MODEL: Karma Revero

TITLE: Radiator Hose Clamp Inspection

Technical Service Bulletin

TB-18-20-01

fig 1a

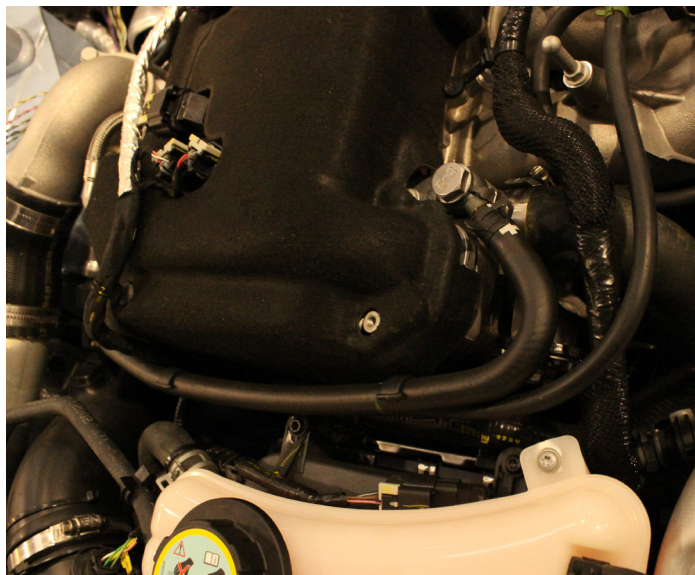
Any vehicle in for service should have the worm drive clamp inspected and set to proper torque as specified. If a vehicle presents leaking coolant from the engine bay, use the following procedure to address the leak. If the leak source is found at engine upper radiator hose (fig 1a) connecting to engine coolant port. Again if it is fitted with a worm drive clamp as shown (fig 1b) **torque to 5.5Nm**. Verify leak is no longer present.

If the vehicle is fitted with a constant tension clamp on the hose, or if the worm gear clamp continues exhibiting the leak concern, replace this with hose and clamp assembly part number C131111401004. Provide images of the hose and clamp location for this concern to TSS.
